STAFF REVIEW

Address: 9 NEW JERSEY AVE (MADAKET)

Scope of Work: NEW DWELLING (EX. DEMOD W/OUT  
APPROVAL) HOC 2023.01.7686 WAS ADDITION +

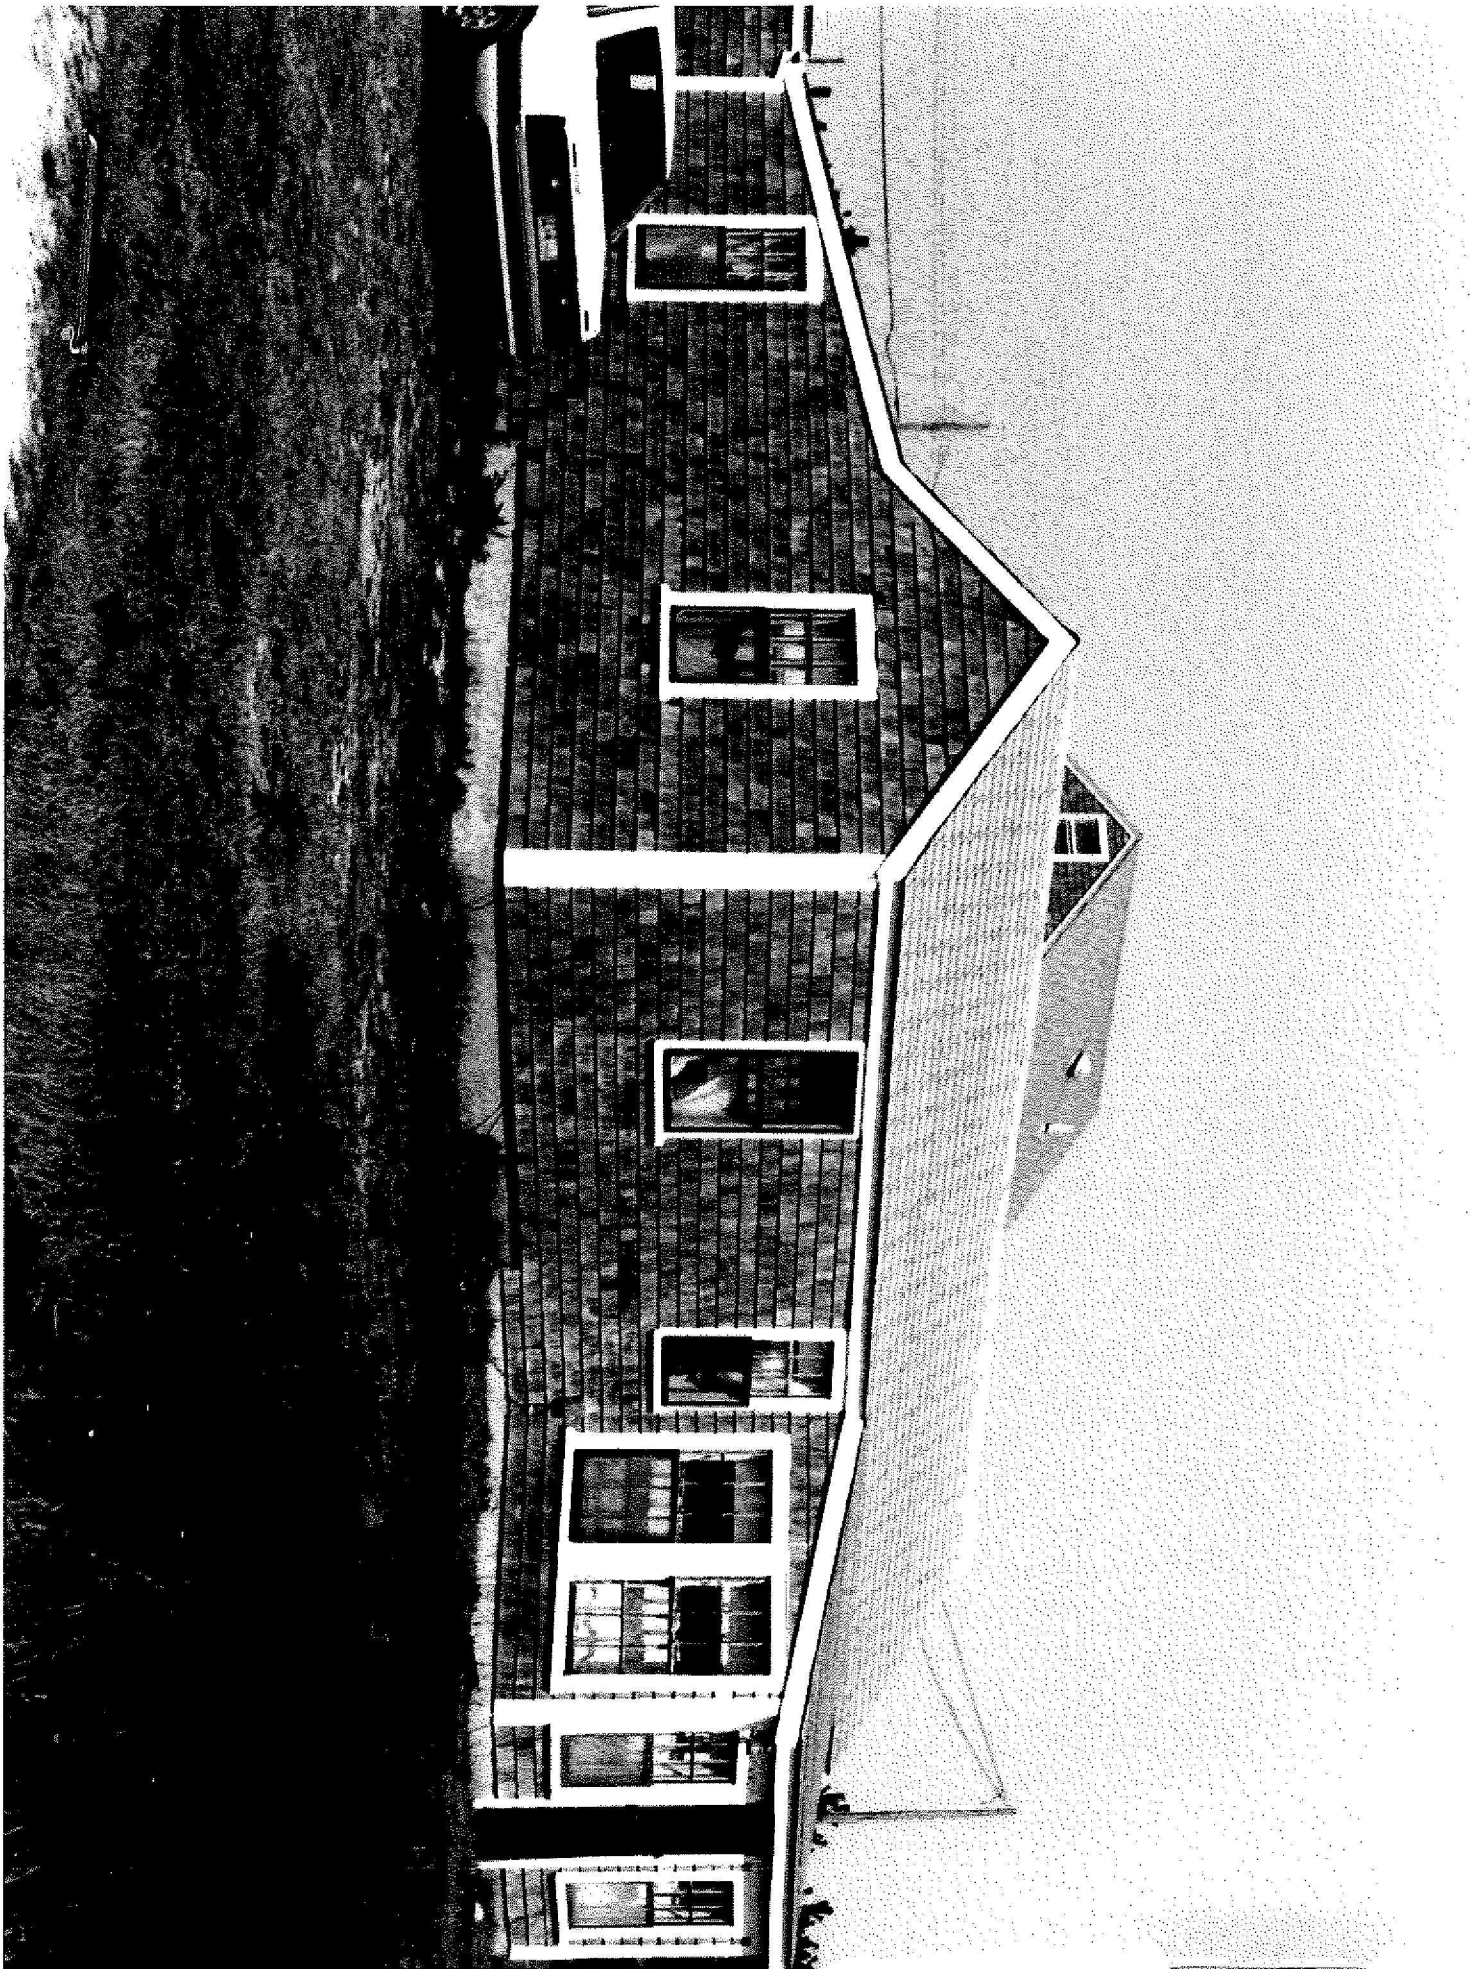
\*APPRECIATE THE PHOTOGRAPHS OF THE DEMOLITION FOR THE FILE, SO STAFF CAN UPDATE THE HOC SURVEY IN THE FUTURE TO DEMOLITION.
